# Access Compliance Report

## Public Rights-of-Way

### (Curb Ramps)

Intersection ID: 52716	Main Street: AGAVA_LN	Cross Street: MAIDENHAIR_CT	Location: SE
ADA ID: B96B0AEC556B	Ramp Type: Perp	Initial Pass/Fail: Fail	Overall Compliance: No
Severity Score: 1.25			
Codes/Mitigation Info/Possible Solution		Field Measurements/Component Compliance

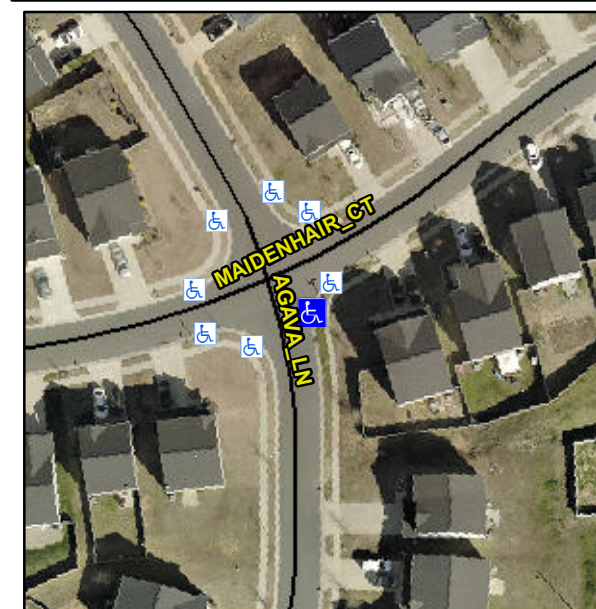
**Not Found, R304.5.3**

Compliance	Description	Data	Compliance	Description	Data
N/A	Ramp Length (in)	48.0	Yes	Ramp Slope (%)	5.5
Yes	Ramp Width (in)	48.0	No	Ramp XSlope (%)	4.6
N/A	Flare Type LT	N/A	N/A	Flare Type RT	N/A
N/A	Flare Slope LT (%)	N/A	N/A	Flare Slope RT (%)	N/A
N/A	Flare Traversable LT?	N/A	N/A	Flare Traversable RT?	N/A
N/A	Landing Length (in)	N/A	N/A	DWS Provided?	N/A
N/A	Landing Width (in)	N/A	N/A	DWS Contrast?	N/A
N/A	Landing Slope (%)	N/A	N/A	DWS Length (in)	N/A
N/A	Landing X Slope (%)	N/A	N/A	DWS Full Width?	N/A
N/A	Landing Curb? (Y/N)	N/A	N/A	DWS Offset (in)	N/A
N/A	Shared Landing?	N/A			
N/A	Gutter Ponding?	N/A	N/A	Gutter Slope (%)	N/A
N/A	Gutter Lip Ht (in)	0.5	N/A	Gutter X Slope (%)	N/A
N/A	Painted X Walk1?	No	N/A	Painted X Walk2?	N/A
	X Walk 1 Direction	To W		X Walk 2 Direction	N/A
N/A	X Walk 1 Width (in)	N/A	N/A	X Walk 2 Width (in)	N/A
	X Walk 1 Slope (%)	2.2		X Walk 2 Slope (%)	N/A
	X Walk 1 X Slope (%)	0.9		X Walk 2 X Slope (%)	N/A

**Remove & Replace Entire Ramp.**
